February 23, 2005
TVA-BFN-TS-418

BROWNS FERRY NUCLEAR PLANT (BFN) - UNITS 2, AND 3 - RESPONSE TO NRC's ACCEPTANCE REVIEW LETTER AND REQUEST FOR ADDITIONAL INFORMATION RELATED TO TECHNICAL SPECIFICATIONS (TS) CHANGE NO. TS-418 – REQUEST FOR EXTENDED POWER UPRATE OPERATION (TAC NOS MC3743 and MC3744)

REPLY TO RESULTS OF ACCEPTANCE REVIEW AND REQUEST FOR ADDITIONAL INFORMATION FOR BFN UNITS 2 AND 3 EXTENDED POWER UPRATE APPLICATION
(Proprietary Version)

SIL 644 Supplement 1
Basic GE Steam Dryer Hood Types

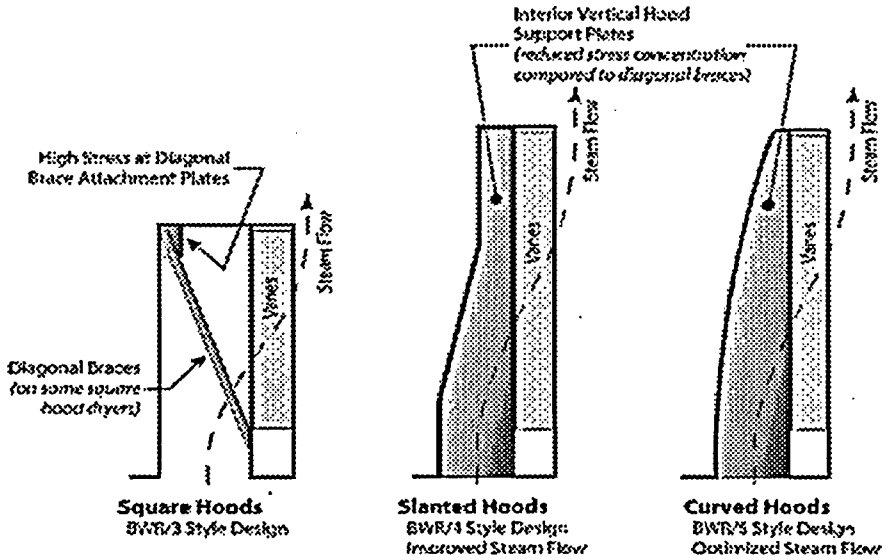
NRC Request 5.a.(1)

The excitation source for flow-induced vibration effects and, thus, the actual applied forcing function on the BFN steam dryer has not been adequately determined.

- Additional reinforcement of the existing cover plate 1/4 inch fillet weld to attain a full 3/8 inch fillet weld.
- A gusset on each dryer hood face is planned that will provide additional reinforcement to the cover plate and hood face. The height of the added gusset will be optimized based on the most mitigating configuration for reducing overall dryer stresses, improving flow straightening contributions and dose reductions for the underwater divers implementing the modifications. Welded attachments to the existing dryer components will invoke the objective of minimum weld stress design approach by increasing the weld area and minimizing weld stress concentrations.
